RICOH **M**odification **B**ulletin **PAGE: 1/1**

Model: Martini-C1 Printer/Scanner Kit Type 1075	Date: 17-Dec-02	No.: MG338001

Modified Article: Operation Instructions			Prepared by: K. Miura
From: Technical Services sec. Service Planning Dept.			
Reason for Modification:	☒ Parts catalog correction ☐ To facilitate assembly ☐ Part standardization	☐ Vendor change ☐ To improve reliability ☐ Other	☐ To meet standards ( )

Printer/Scanner Kit Type 1075

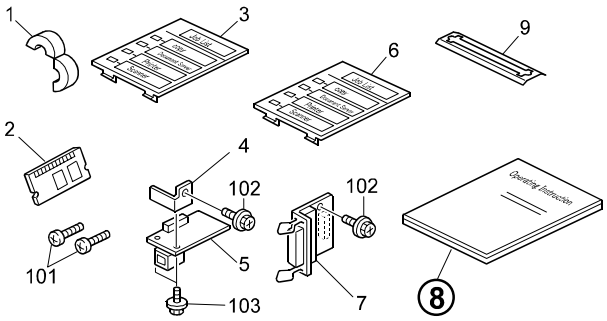
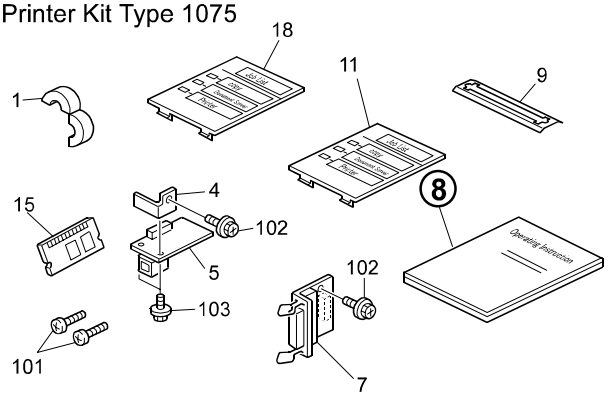
Please correct your Parts Catalog as follows:

Old part number	New part number	Description	Q'ty	Int	Page	Index	Note
G3388612	G3398609	Operating Instructions - PRN - TWN	1	_	3	8	
G3388613	G3398606	Operating Instructions - PRN - CHN	1	_	3	8

Printer/Scanner Kit Type 1075

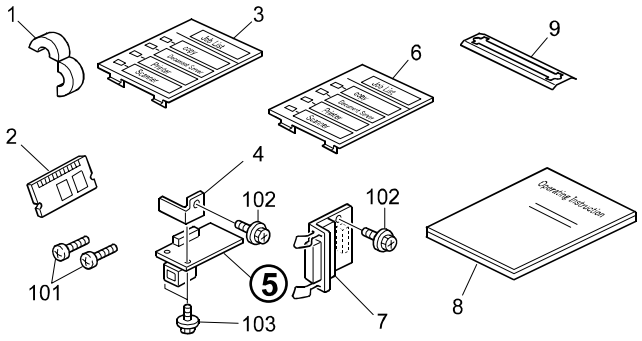
Please correct your Parts Catalog as follows:

Old part number	New part number	Description	Q'ty	Int	Page	Index	Note
B0535254	B0535166	Network Interface Board	1	_	3	5

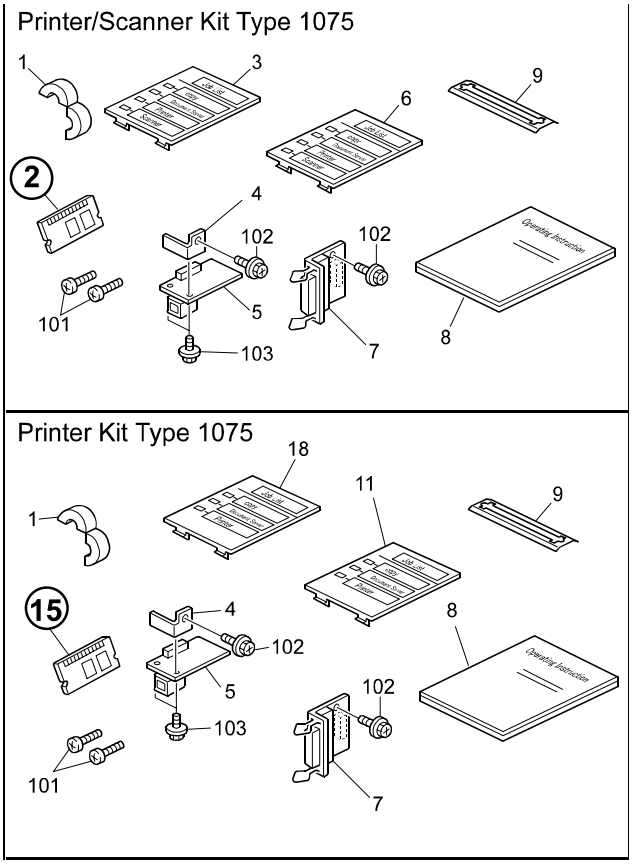
When printing with the PS driver, the Euro currency symbol is not printed out with 112 of the 136 fonts that are stored in the font ROM. To prevent this, the following parts have been changed:

Old part number	New part number	Description	Q'ty	Int	Page	Index	Note
G3385117	G3385118	Printer/Scanner DIMM	1	X/O	3	2	
G3395117	G3395118	Printer DIMM	1	X/O	3	15

For the details, please refer to RTB#Rgen011.

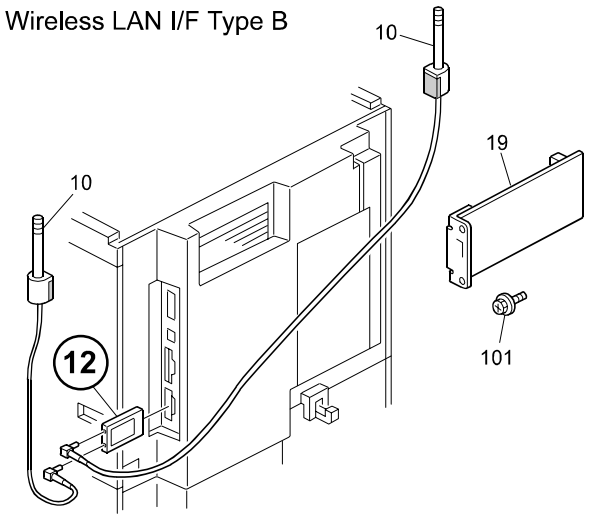
The following part has been changed due to a vendor change.

Old part number	New part number	Description	Q'ty	Int	Page	Index	Note
G6285453	G6285461	Wireless Card - US	1	X/X	3	12	
G6285454	G6285462	Wireless Card - EU	1	X/X	3	12

Note: When installing the new Wireless Card, it is necessary to upgrade the GW controller and NIB/NetFile firmware. For details, please refer to RTB #RB064019 and #RB064030.
